Date: July 11, 2024
To: Anthony P. Esson Architect
Project Name: Johannesburg Lewiston Area Schools (JLAS) 2024 Projects
Bid Package #1 – Johannesburg Water Well Upgrades
JLK Project Number: AEA 2402
Prepared by: Justin Kowatch, PE
Addendum Number: #1 – Electrical Items

ADDENDUM

Drawings –
JLAS BP#1 Wellhouse Electrical Rebid Plans: E1.1 & E2.1, both dated 7/11/2024.

NORTH
 NEW WELLHOUSE - ELECTRICAL OVERALL PLAN
 SCALE: 1" = 20'-0"

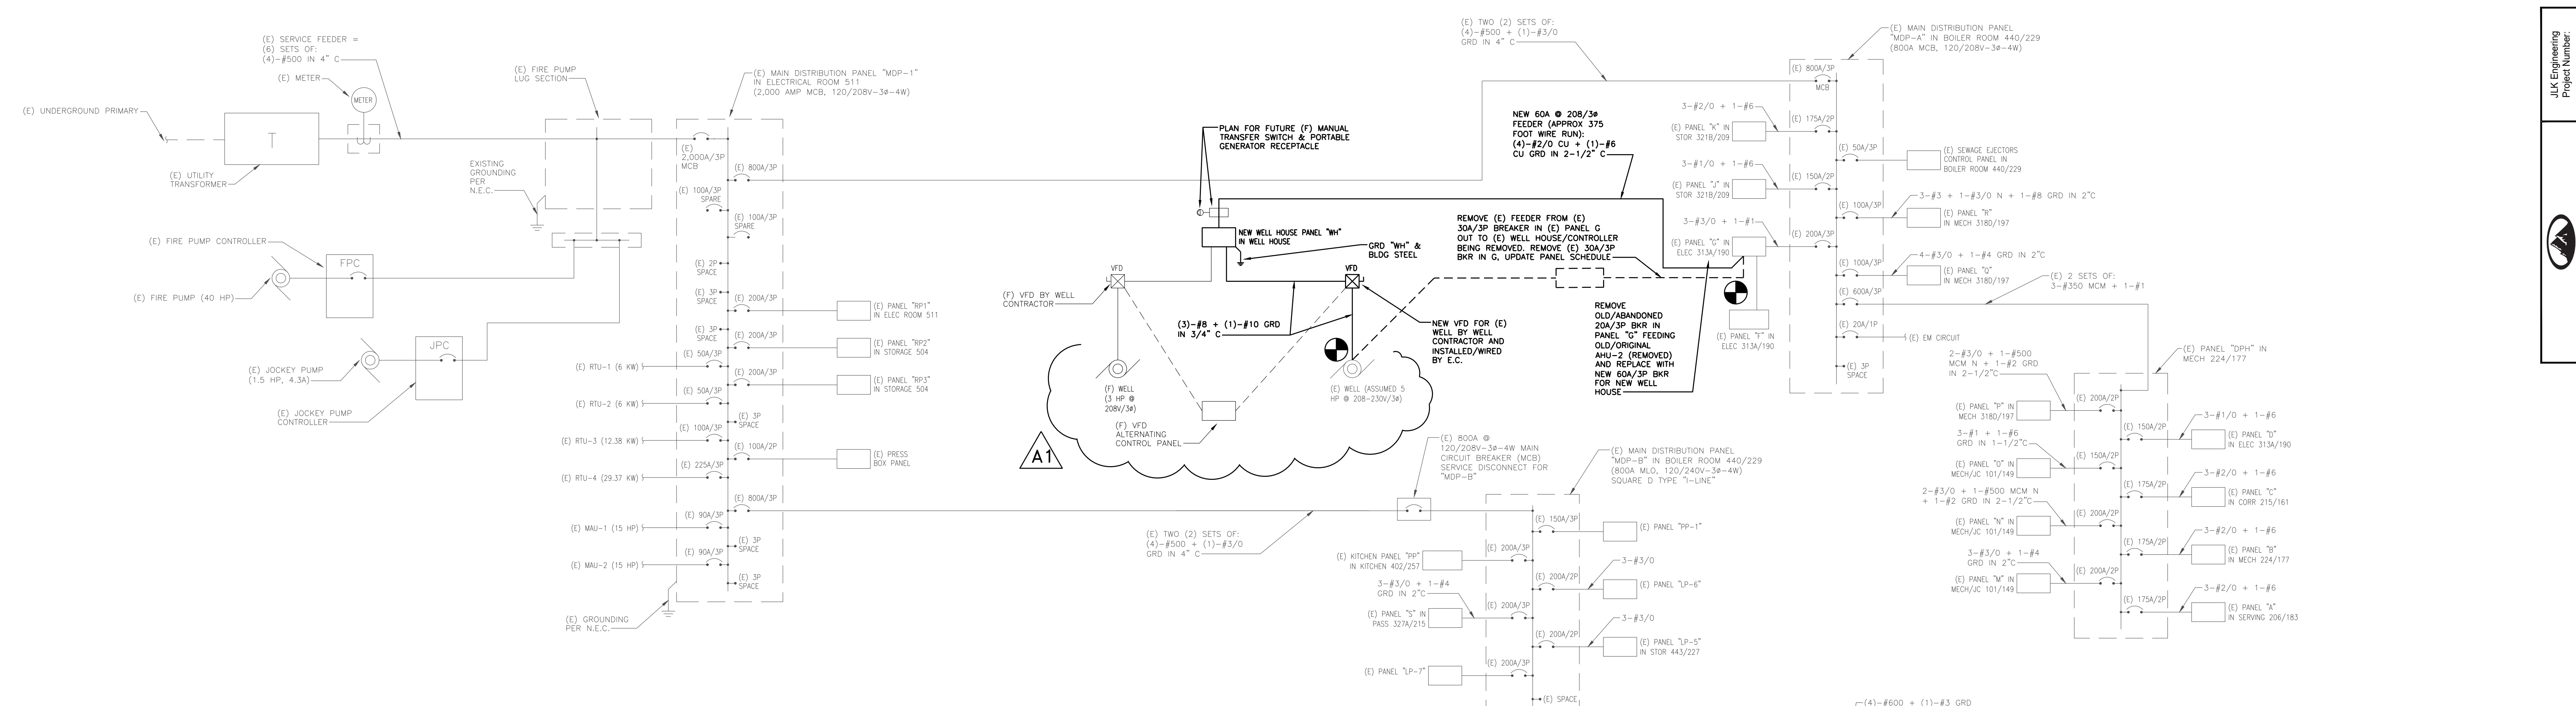
- A. Clarified that the existing well is 5 hp and changed breaker size from 20A/3P to 35A/3P.
